Date: 2/7/2023  
To: Plan Review  
(Person's Name and Division)  
From: Chris Choi (301) 312-1791  
(Your Name, Company Name and Telephone Number)  
Subject: Project name New Shed  
Project site address 14821 Burntwoods rd., Glenwood, Md. 21738  
Permit # B21003755 SDP # \_\_\_\_\_  
Other information pertinent to this project \_\_\_\_\_

Date: February 7, 2023

Permit# B21003755

Purpose of this letter is to describe the plan change to the original permit# B21003755. Original plan was to build a very large custom Shed/building in the front yard, on a concrete slab, in addition to the existing current shed. The new change will do the following:

proposed shed#5  
12'x24'

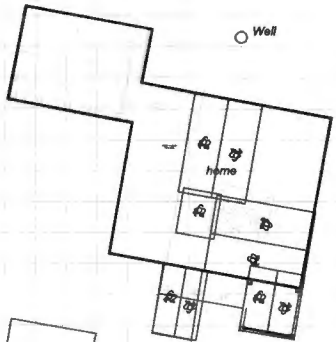
1. The new shed will now be replacing the existing current shed, in the same location as the existing current shed. Existing shed will be removed, and new one will go in its place.
2. The new shed will be placed on a gravel pad
3. The new shed is a prebuilt unit that gets delivered and placed.
4. The new shed is purchased and installed by "High Point buildings", company information is,
